Rezoning Transportation Analysis

Petition Number: 2025-131

Reviewer: Brent Hyatt, PE
Brent.Hyatt@charlottenc.gov
704-942-7460

Date	Description
1-22-26	First Review (BH)
2-19-26	Second Review (BH)
3-26-26	Third Review (BH)

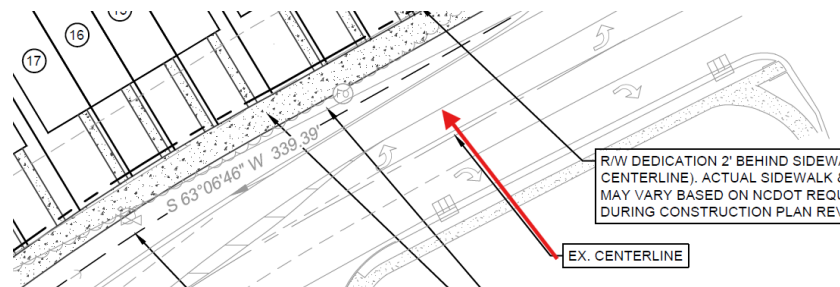
- a. **Grier/Rocky River Road:** Future back of curb and gutter is to be located 30 feet from road centerline and must be shown in the future location according to UDO Article 32.7 and Charlotte Streets Map.

Arterial 4+ Avenue with Shared Use Path (Charlotte Streets Map).

Label and dimension the existing and future back of curb and gutter from the centerline for each road on the site plan.

CLARIFYING COMMENT 2-19-26: Revise callout/leader of "EX. CENTERLINE" to show existing striped center dividing line and show 2 westbound through-lanes along project frontage.

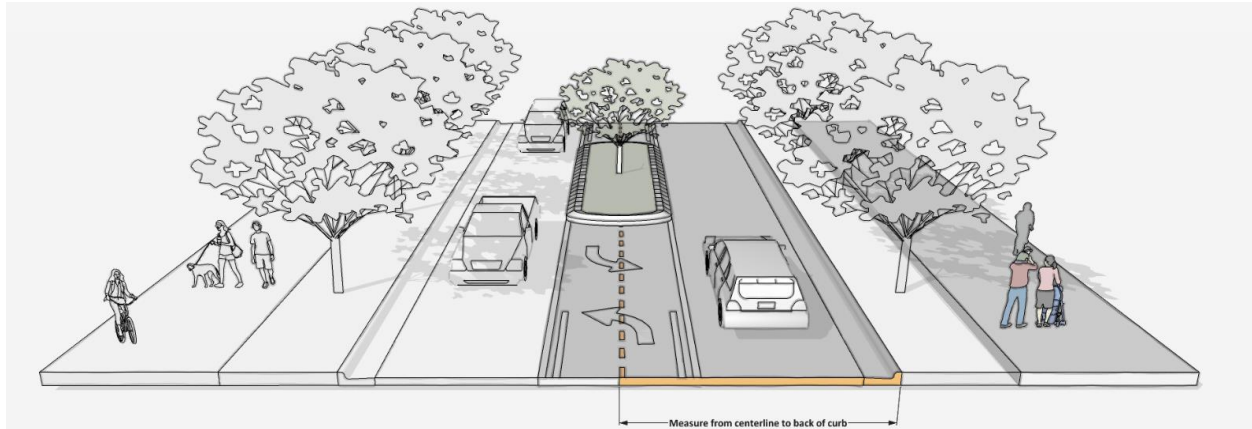
- b. **Rocky River Road:** Future back of curb and gutter is to be located 19-feet from road centerline and must be shown in the future location according to UDO Article 32.7 and Charlotte Streets Map.

2+ Avenue, Shared Use Path

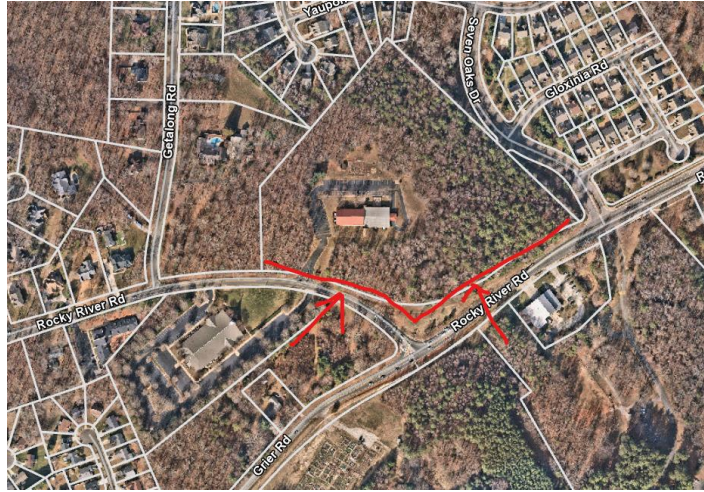
NEW COMMENT 3-26-26: This petition has been reviewed per subdivision requirements, and it was determined that street improvements are required along the entire frontage of the parcel in accordance with UDO Article 32.7. An 8-foot planting strip and a 12-foot Shared use path is required along the entire Grier Road and Rocky River Road frontages, not just the development area. Include ramps at the corner of Grier and Rocky River. Curb and gutter is required to be constructed per Charlotte Streets Map. See comment 1 for curblines locations for both frontages. Show these improvement on the site plan along with callouts and dimensions from the roadway centerline. Add conditional notes to commit to installing these improvements. CDOT is scheduling a meeting with NCDOT to discuss the curblines requirements. Please reach out to Brent.Hyatt@charlottenc.gov to confirm curb line requirements per NCDOT discussion.

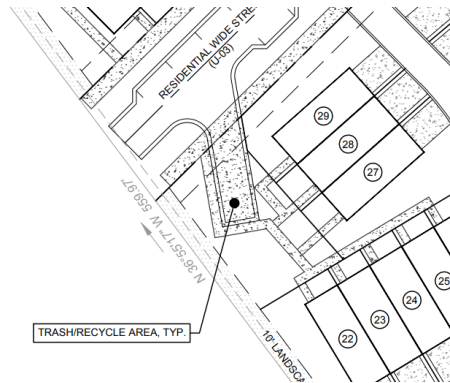
- Revise site plan and conditional notes to commit to providing internal public road as Local Residential Wide Street with 8' planting strip and 8' sidewalk. Label and dimension the future back of curb and gutter from the centerline of the proposed road.

CLARIFYING COMMENT 2-19-26: Label and dimension the future back of curb and gutter from the centerline of the road on the site plan.
